**FINAL FOUNDATION INVESTIGATION REPORT FOR
NOVAR ROAD UNDERPASS
HIGHWAY 11 FOUR LANEING
6.7 km NORTH OF HWY 60 NORTHERLY 13 km
W.P. 462-93-00, SITE 42-235
DISTRICT 52, HUNTSVILLE**

**Re: Novar Road Underpass, Highway 11
Pile Capacity and Length**

Re: Draft Foundation Investigation and Design Report Review
Novar Road Underpass
WP 464-96-01, Site 42-235

Re: Draft Foundation Investigation and Design Report Review
Novar Road Underpass
WP 464-96-01, Site 42-235

FIGURE B1

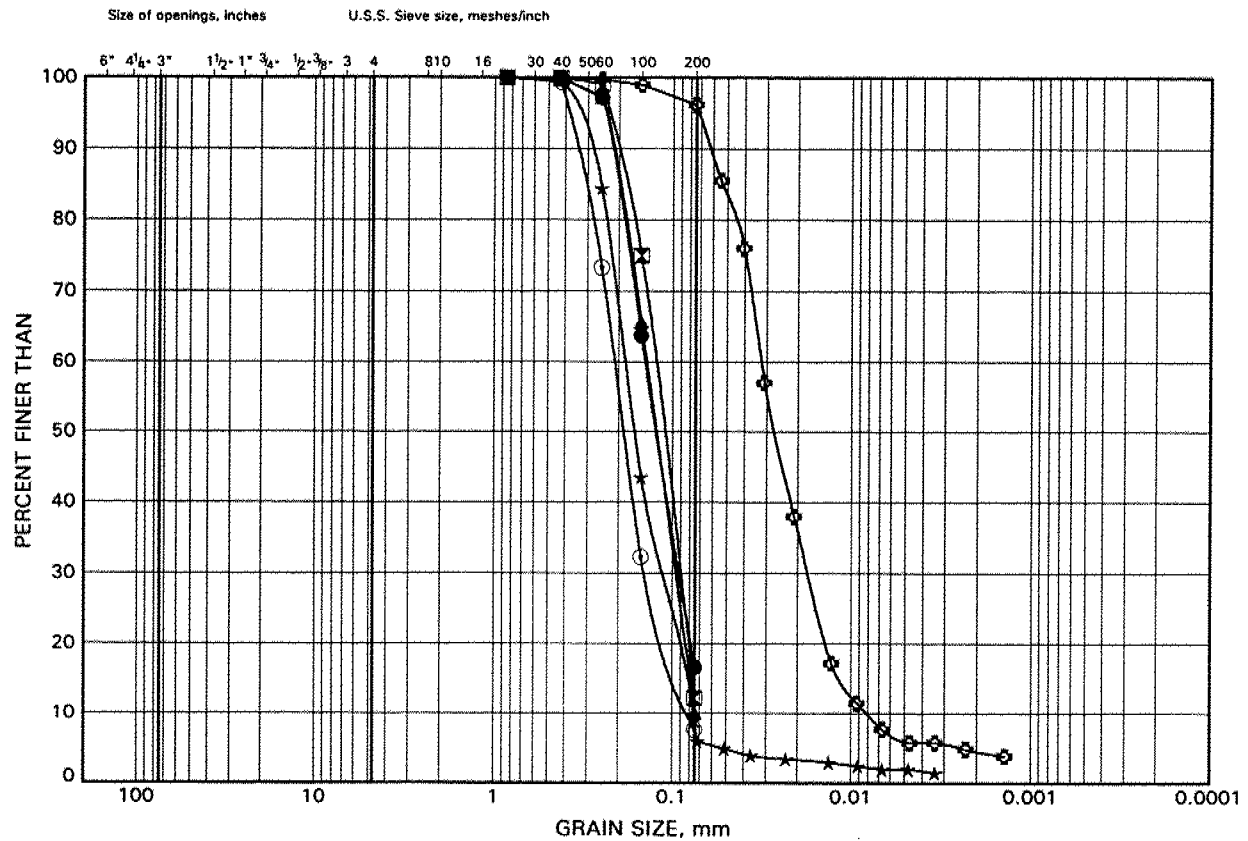
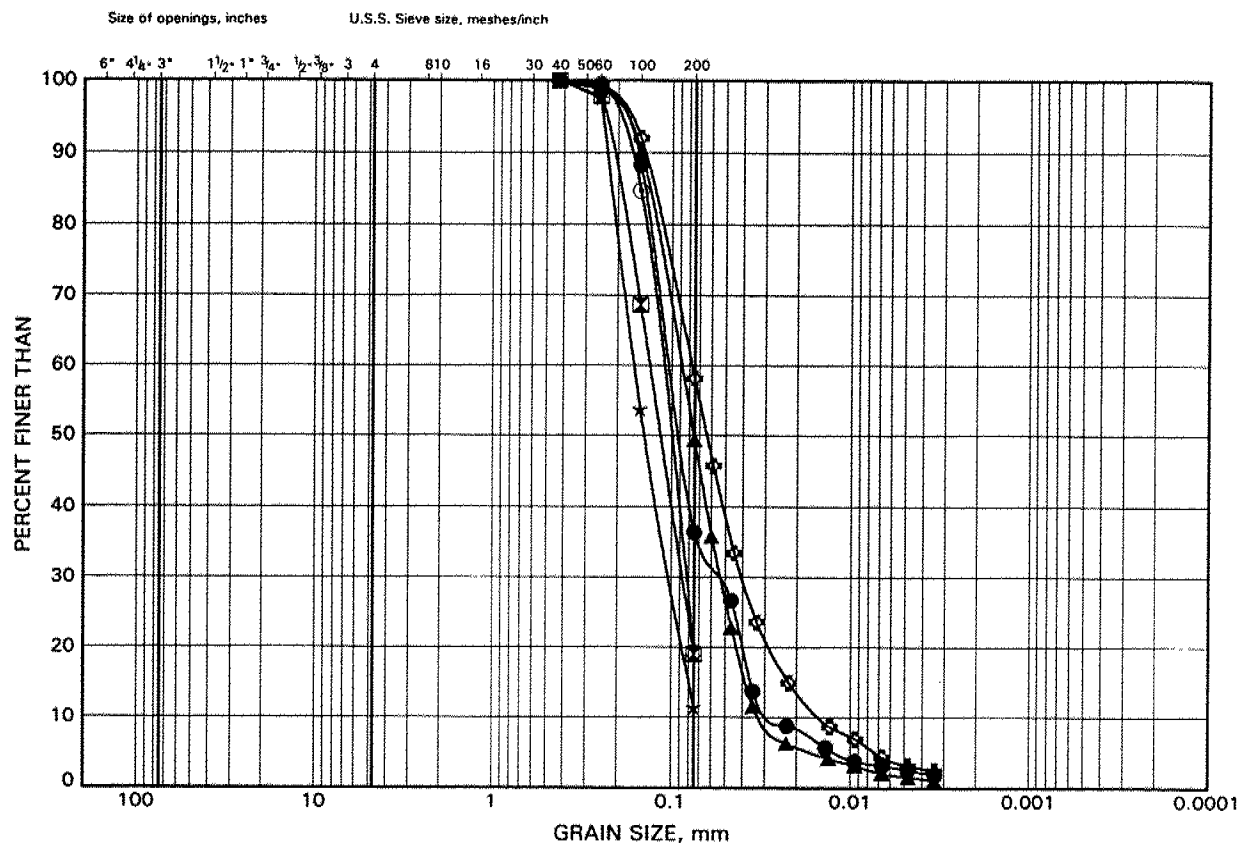
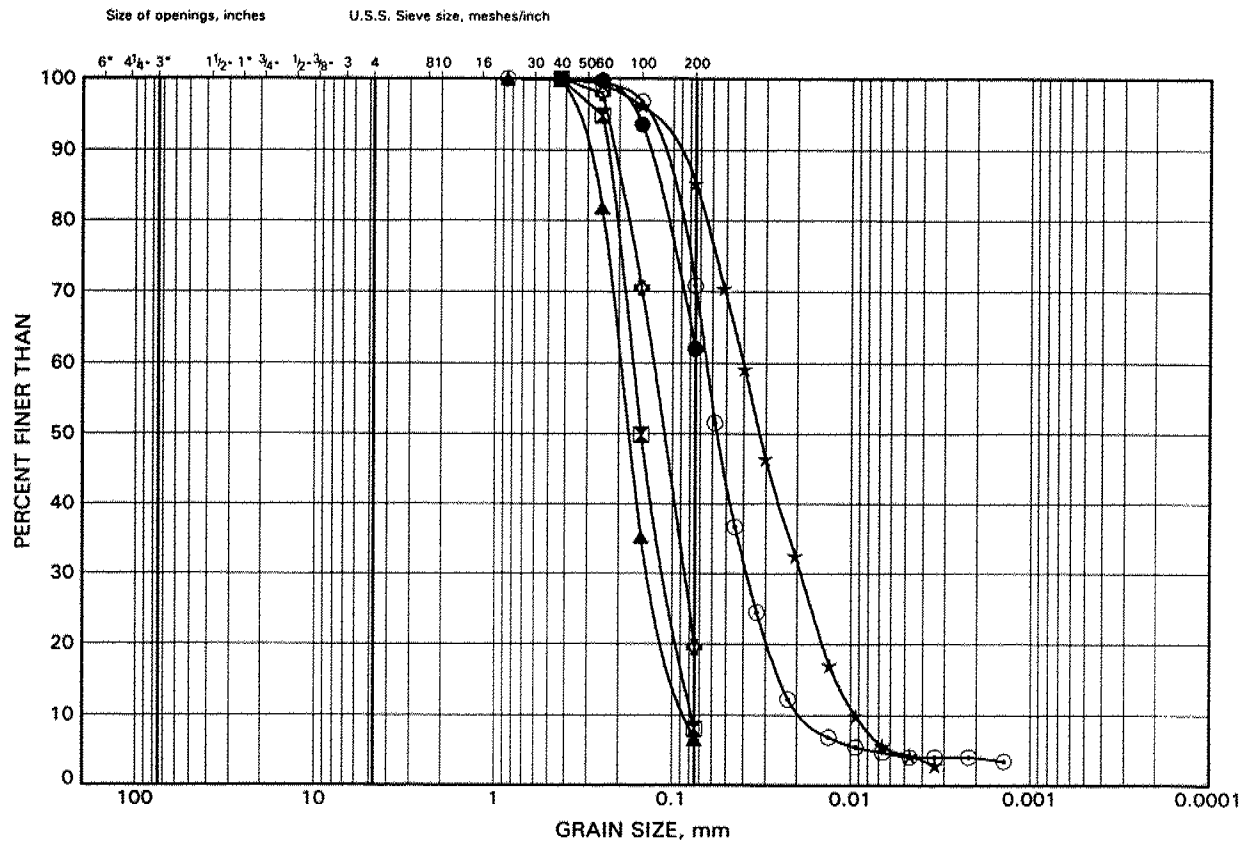
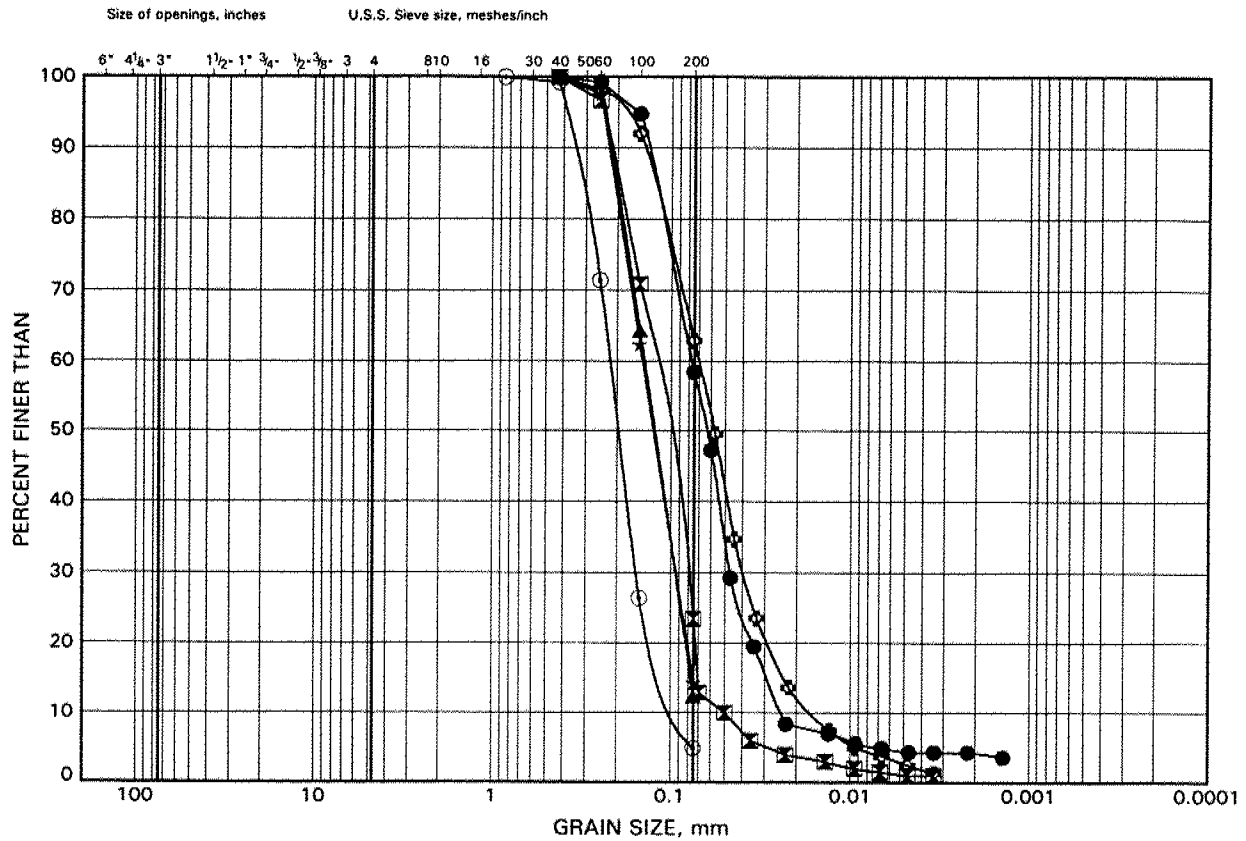
Figures B1 to B4 are not to MTO standards. The figures should present the different soil strata separately.

Figures B1 to B4 are not to MTO standards. In fact, the title of Figures B1 to B4 identify the CNR Overhead structure.
